SUBJECT: LICENSEE'S 10 CFR 50.59 EVALUATION OF MAIN STEAM LINE BREAK
(MSLB) REANALYSIS AND EFFECT ON ISOLATION VALVE CUBICLE
(IVC) AND REACTOR CONTAINMENT BUILDING (RCB)
(TAC NOS. M98914 AND M98915)

Originating Document No. USGE 95-0013Revision No. 0TITLE CN-1462 Revise analysis of the Main Steam Line
Break in the IVC and PCB

TITLE MSLB Blowdown Model for IVC

Change Number 1962 Date 3/29/95
 Originator Charles Albany Dept NPLA
 Change Description Main Steam Line Break in IVC

Figure 3.6.A-3

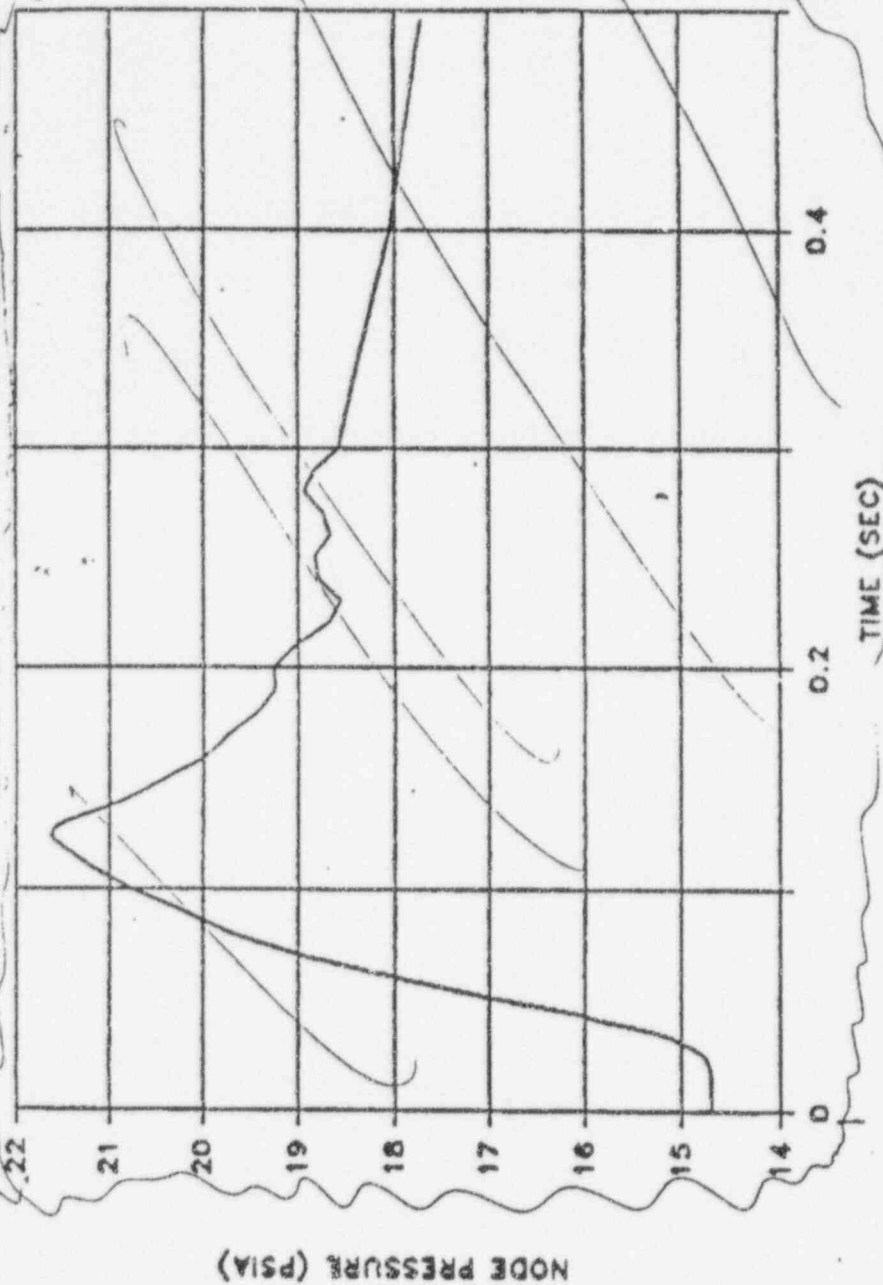
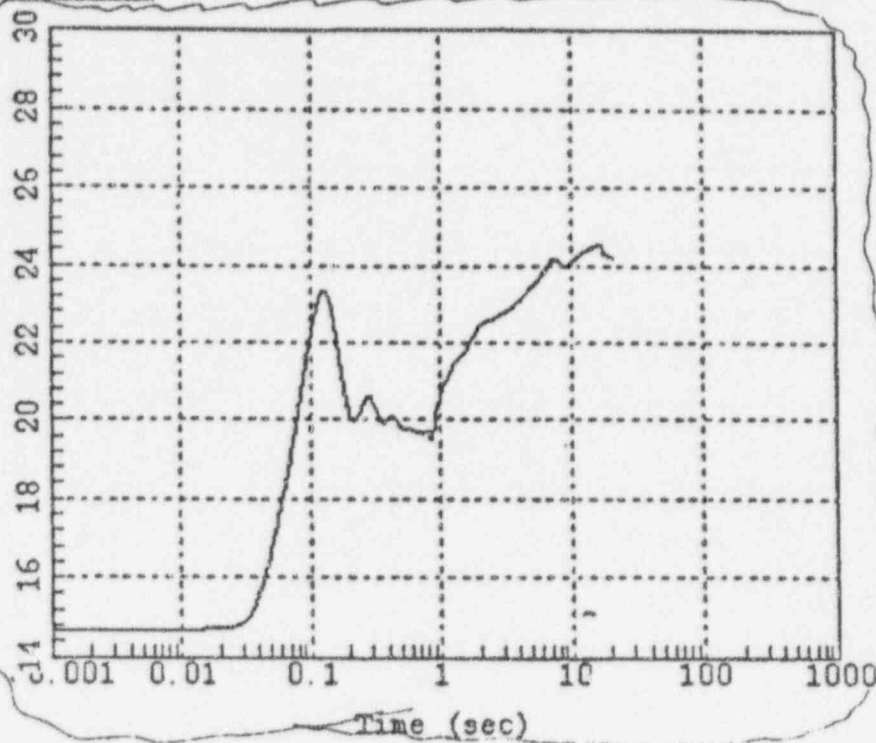
Replace with attached Figure 1

Figure 1

Figure 3.6.A-3

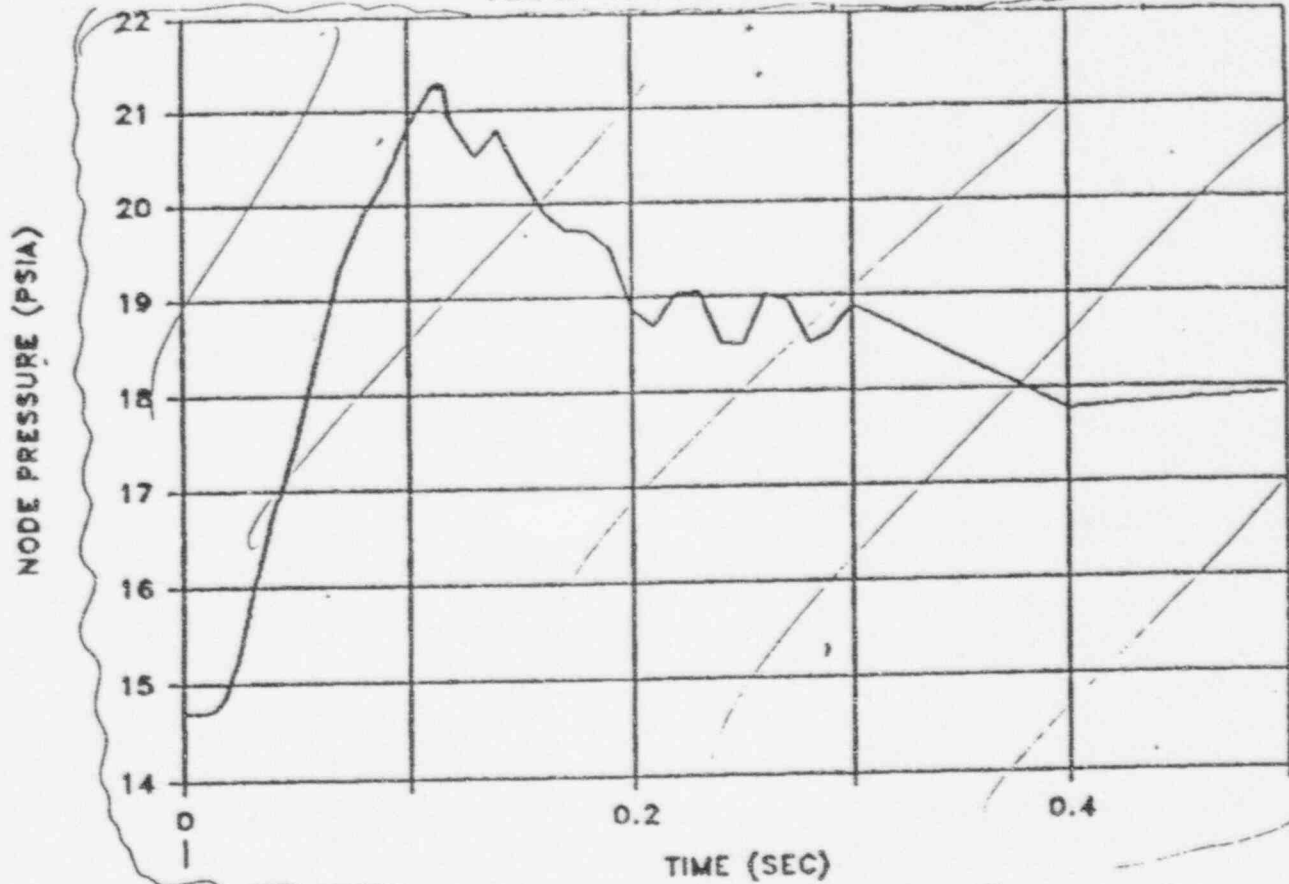
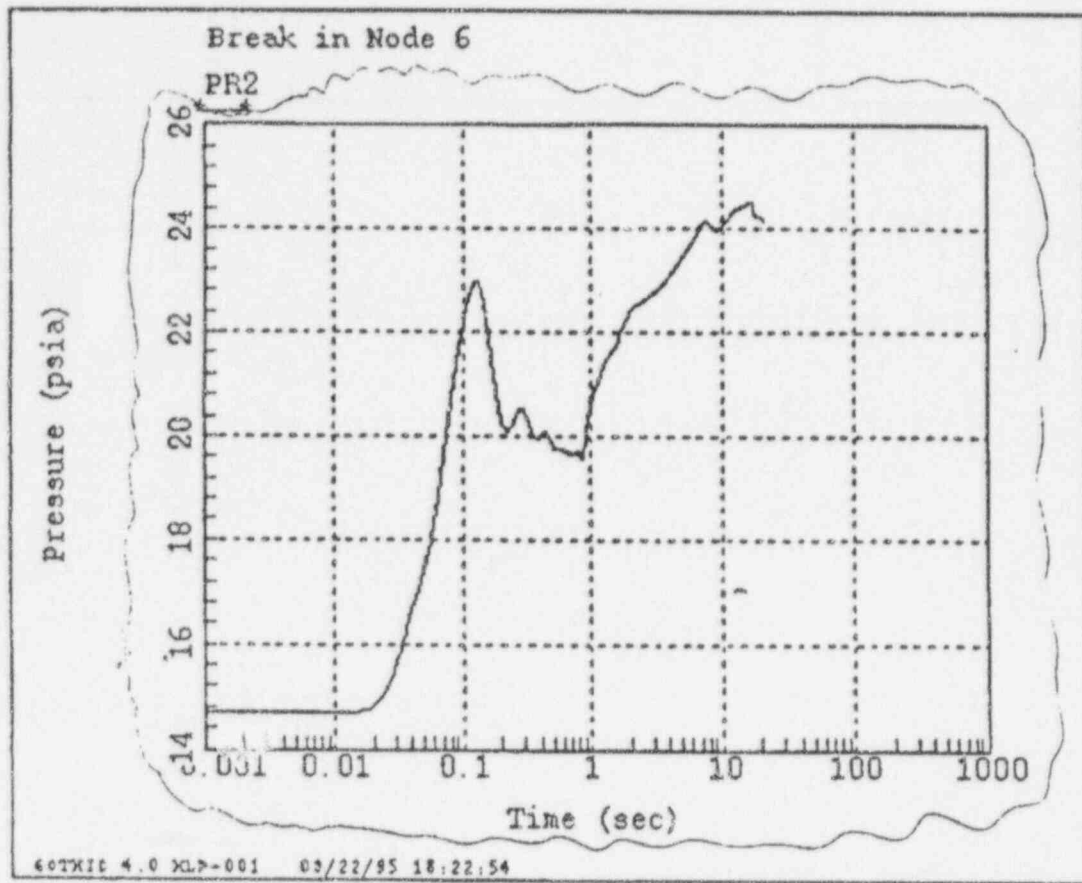
Replace with attached Figure 2

Figure 3.6.A-3

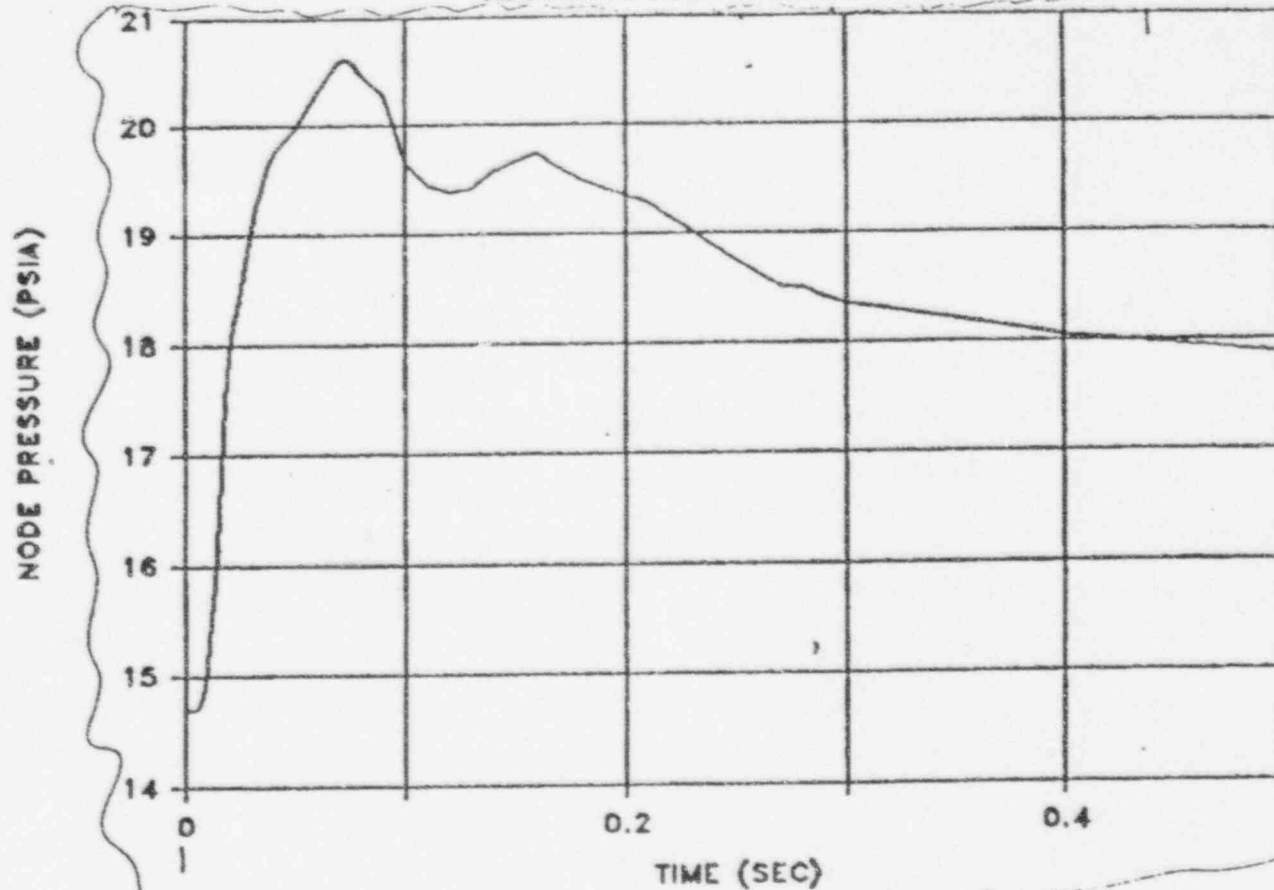
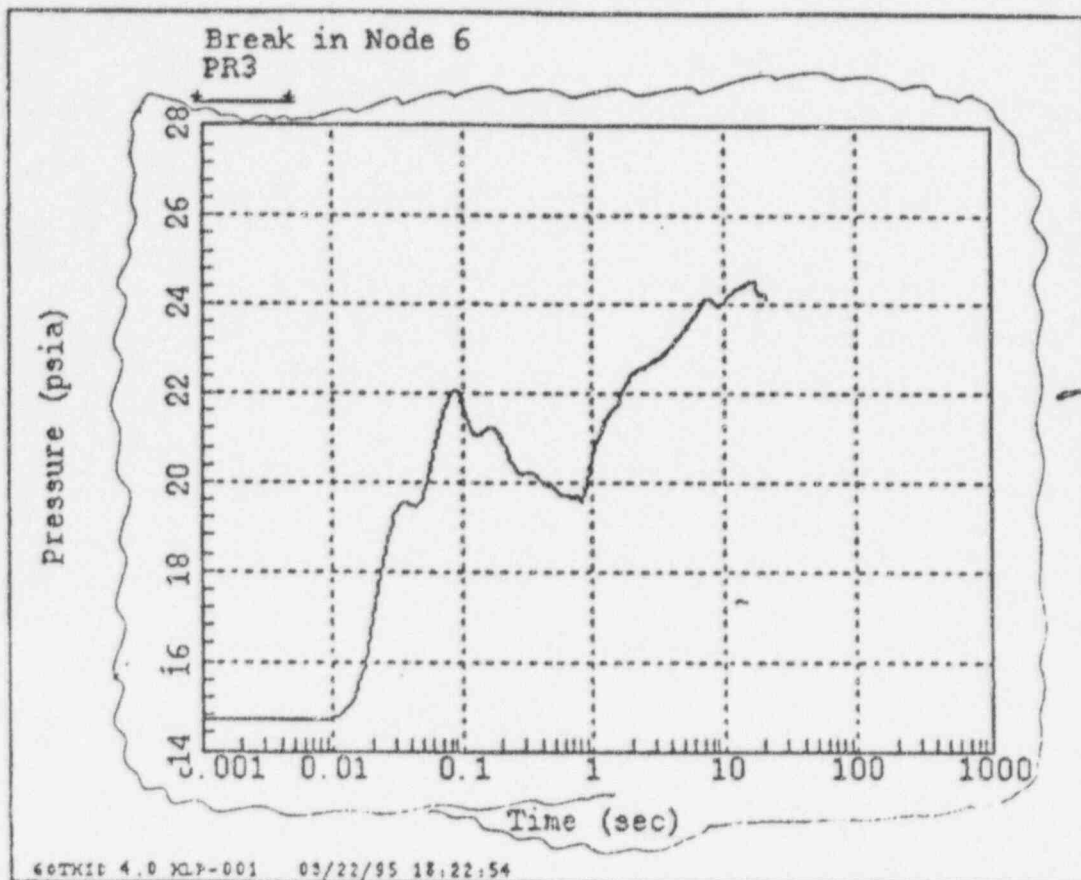
Replace with attached Figure 3

Figure 3

Figure 3.6.A-3

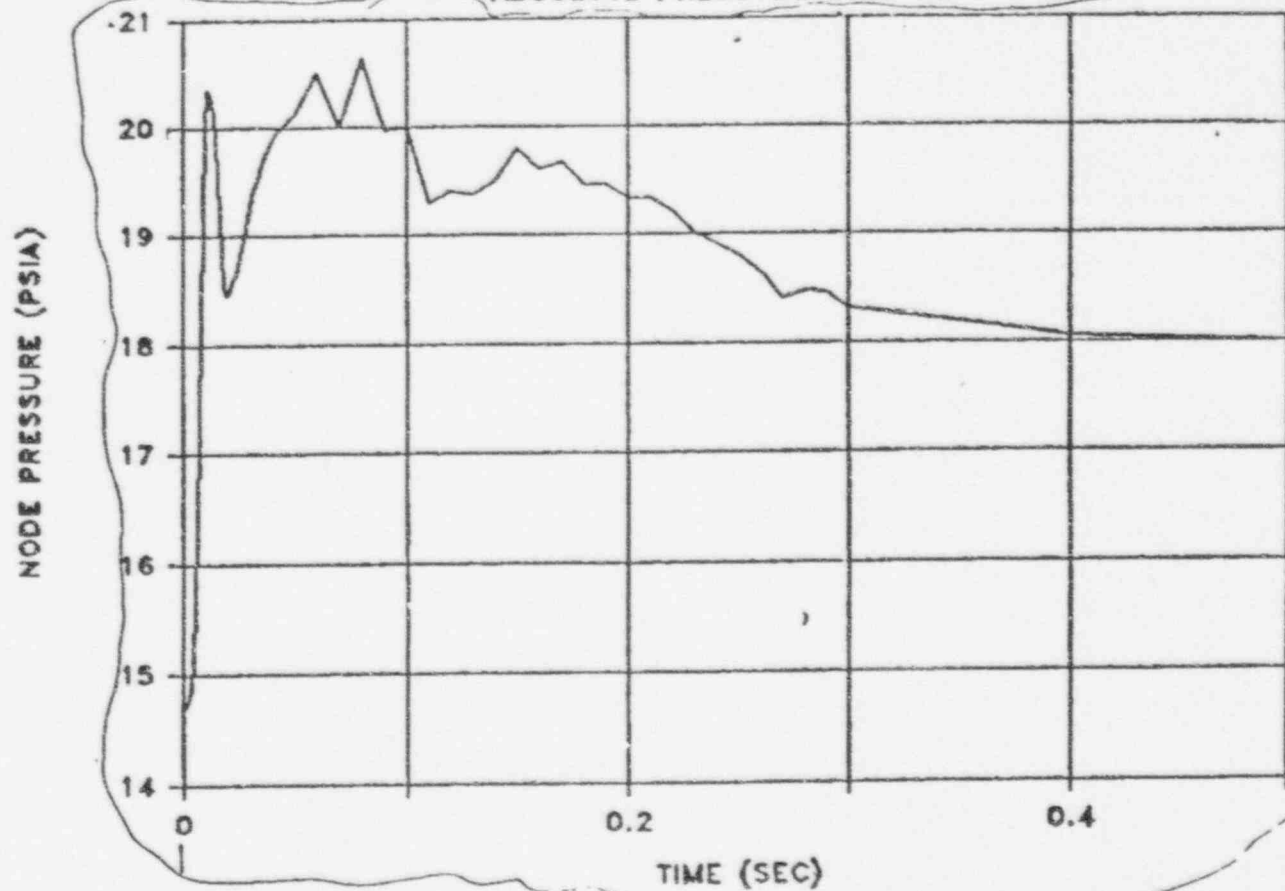
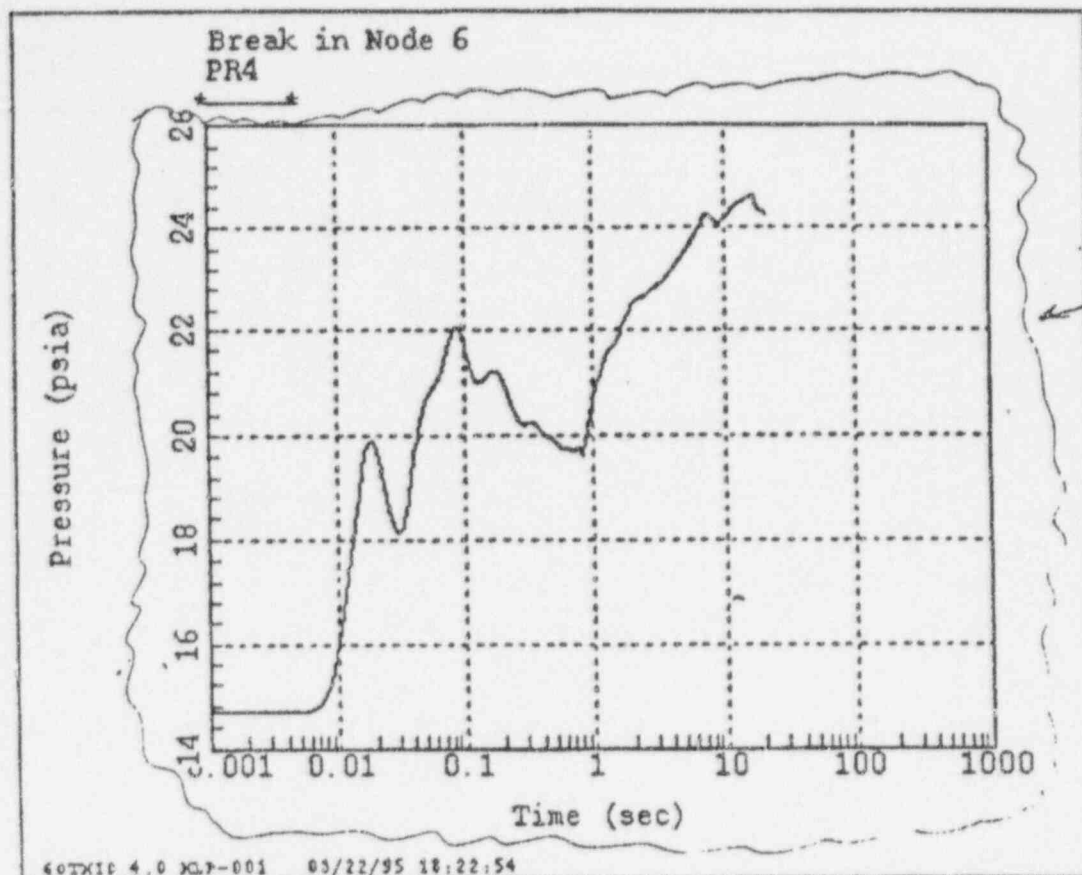
Replace with attached Figure 4

Figure 4

Figure 3.6.A-3

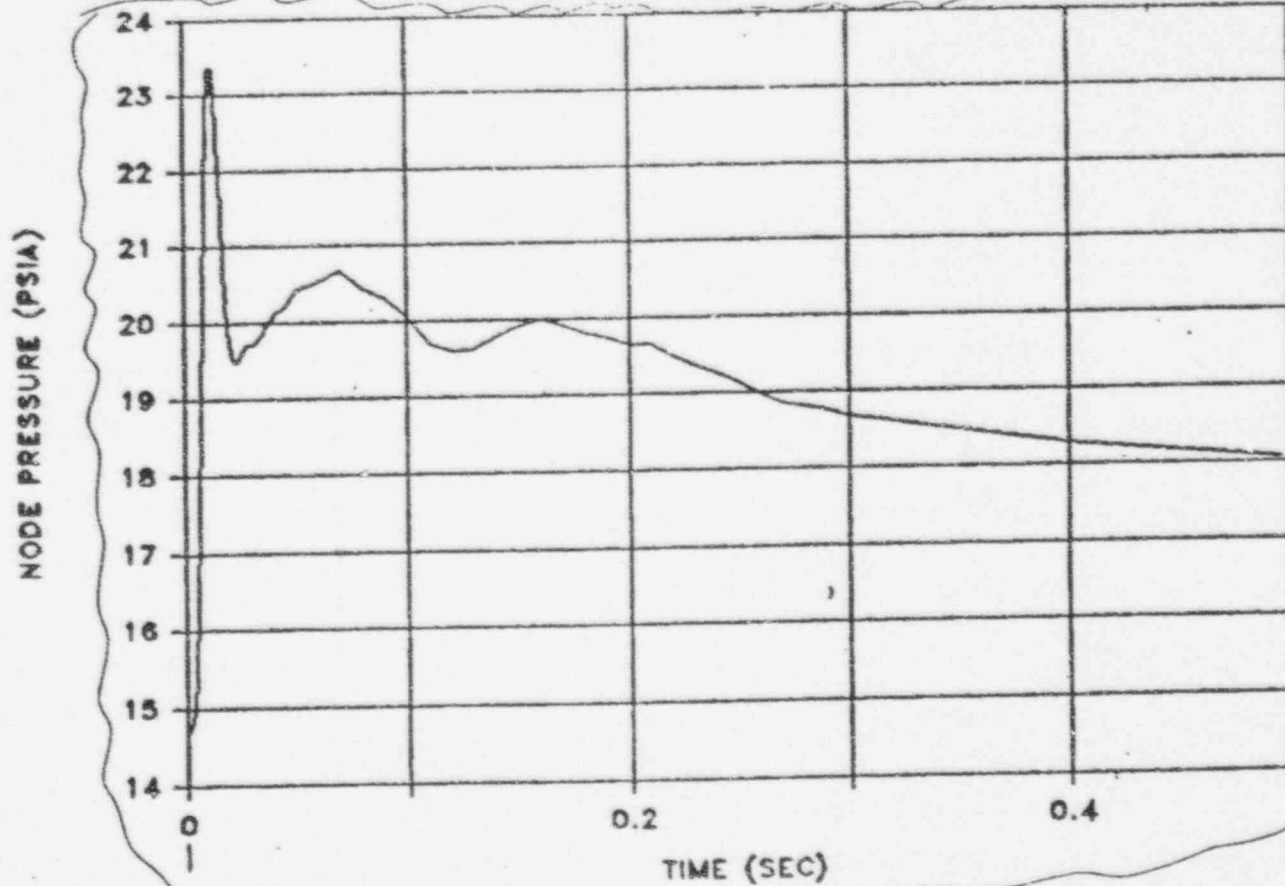
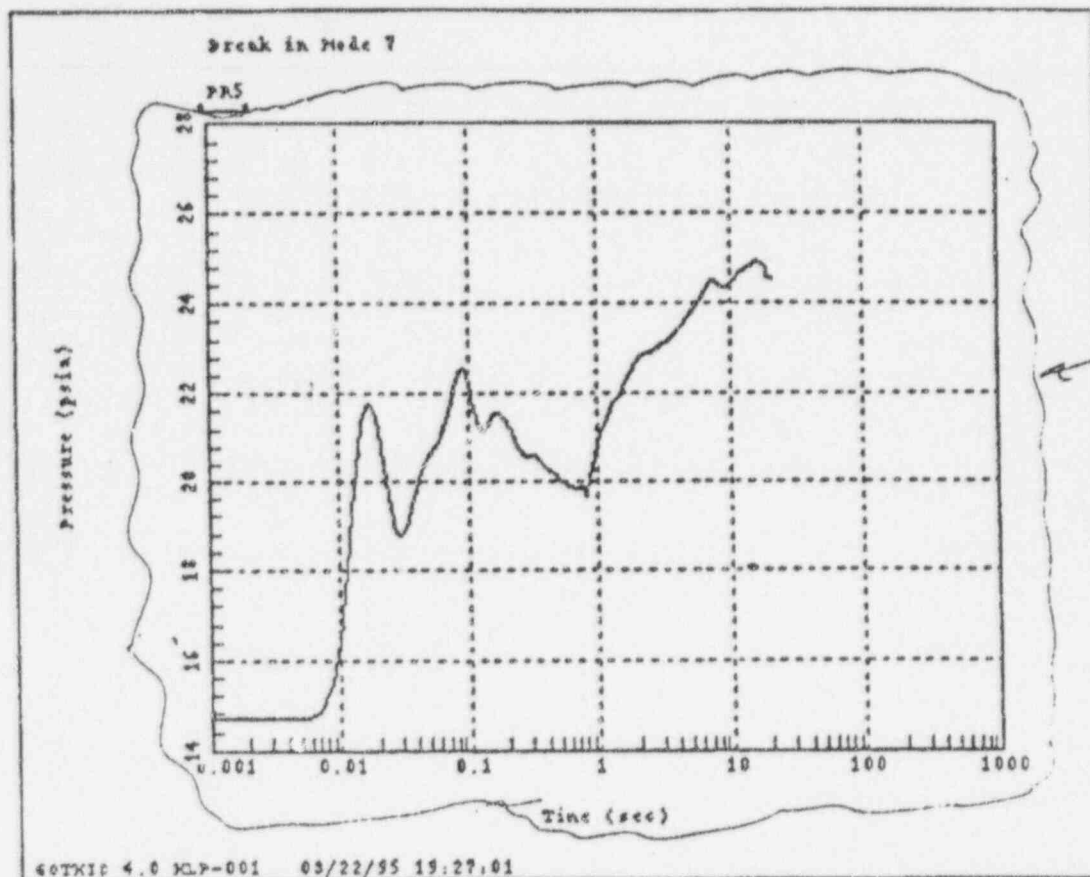
Replace with attached Figure 5

Figure 5
